# Technical Service Bulletin

15 Oil leak and/or camshaft DTCs stored - 3.0L

15 08 09 2005587/6 November 7, 2008. Supersedes Technical Service Bulletin Group 15 number 08-08 dated 2005587/5 for reasons listed below.

Model(s)	Year	VIN Range	Vehicle-Specific Equipment
A4	2002 – 2005	All	3.0L V6 Engine
A4 Cabriolet	2003 – 2006	All	
A6	2002 – 2004	All

Figure 2. The gasket (1), camshaft adjustment housing (B), camshaft sealing rings (2) and O-rings (3).

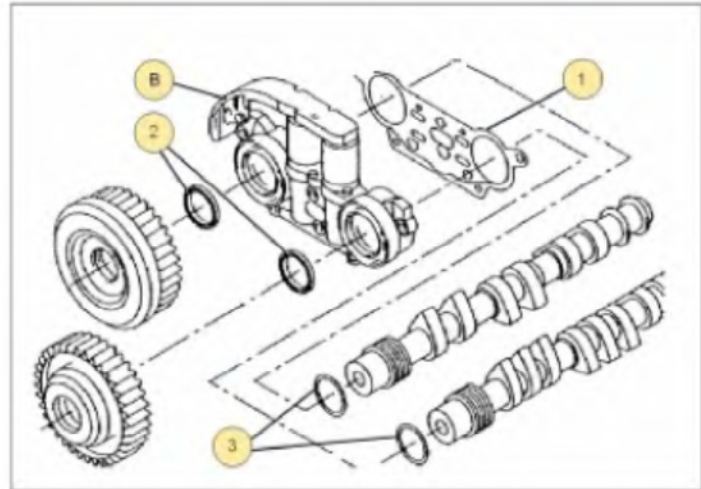
REVISION HISTORY		
Revision	Date	Purpose
6	-	<ul style="list-style-type: none"><li>Revised <i>Service</i> (Step 5b and Figure 2)</li><li>Revised <i>Warranty</i></li><li>Revised <i>Required Parts and Tools</i></li></ul>

- a. Do not replace the camshaft adjusters (Figure 1, A) or camshaft adjustment housings (Figure 1, B)
- b. Replace gasket (Figure 2, 1) and O-rings (Figure 2, 3) between camshaft adjustment housing (Figure 2, B) and cylinder head.

Replace both camshaft sealing rings (Figure 2, 2) (See Repair Manual, Group 15, "Camshaft and camshaft adjusters, removing and installing")

Figure 3. The outer bolts (3), caps (4), and O-Rings (5).

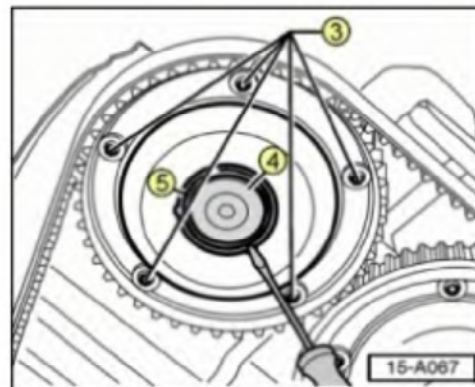
1. Retorque all five outer bolts (Figure 3, 3) on all four camshaft adjusters to 15 Nm. (The bolt heads are located on the back side of the camshaft adjuster gears.)
2. Replace missing or damaged bolts (part number WHT 003 121).
3. Replace caps (Figure 3, 4) and O-Rings (Figure 3, 5) and secure with securing ring (See Repair Manual, Group 15, "Camshaft and camshaft adjusters, removing and installing.")
4. Reassemble removed components and complete the repair.
